DUBROCA TRACT SUBDIVISION, BLOCK 25, **RESUBDIVISION OF LOT 4**

APPLICATION NUMBER 8 DATE December 1, 2016

REQUEST Subdivision

DETAIL SITE PLAN

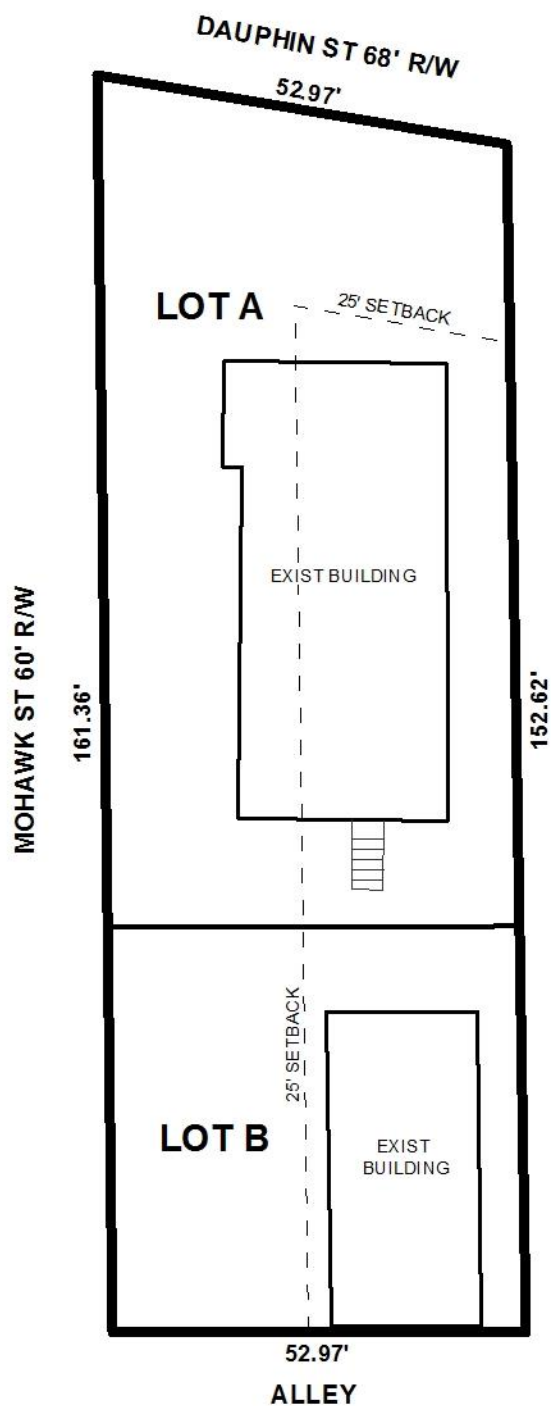
- B. Review and revise the written legal description to match the written bearings and distances.
- C. Dedicate the corner radius (25' minimum or as approved by the City Engineer and Traffic Engineer) at the northwest corner of LOT A.

Dedication of the corner radii at the intersection of Dauphin Street and Mohawk Street, as well as at the intersection of Mohawk Street and the unimproved alley, should be required per Section V.D.6. of the Subdivision Regulations.

With regards to access management, proposed Lot A does not currently have access to Dauphin Street; instead, both proposed lots currently have access to Mohawk Street via a single curb cut each. As such, a note should be required on the Final Plat stating each lot is limited to its existing curb cut, with any changes in their sizes, designs, or locations to be approved by Traffic Engineering and conform to AASHTO standards. An additional note should state that Lot B is denied access to the unimproved alley.

Neither lot meets the minimum size requirements of Section V.D.2. of the Subdivision regulations, with proposed Lot A encompassing 5,506± s.f. and proposed Lot B encompassing 2,747± s.f. Additionally, each lot is substandard in width, with proposed Lot A being 52.97'± wide along Dauphin Street, and proposed Lot B being 52'± wide along Mohawk Street. The applicant references several addresses with respect to establishing precedence regarding

With regards to the sizes of the proposed lots, they are illustrated in both square feet and acres on the preliminary plat and, if approved, should also be illustrated on the Final Plat; or, a table providing the same information may be furnished on the Final Plat, if approved.

The 25-foot minimum building setback is also illustrated on the preliminary plat along both street frontages and should, therefore, be retained on the Final Plat, if approved.

Finally, if approved, it should be noted that the site will require Side and Rear Yard Setback Variance approvals to amend the original Variance site plan to accommodate the new configuration of the site due to the subdivision with respect to: 1) the carport extension of the existing garage apartment encroaching on what would become its side yard; and 2) to accommodate the existing garage apartment encroaching on what would become its rear yard. It should also be noted, however, that neither structure would exceed the maximum allowable site coverage of 35%.

- 1) proposed lot sizes do not comply with Section V.D.1. of the Subdivision Regulations;
- 2) dedication of right-of-way along Dauphin Street would further reduce the size of proposed Lot A; and
- 3) approval of the subdivision would result in lots out of character with the surrounding area.
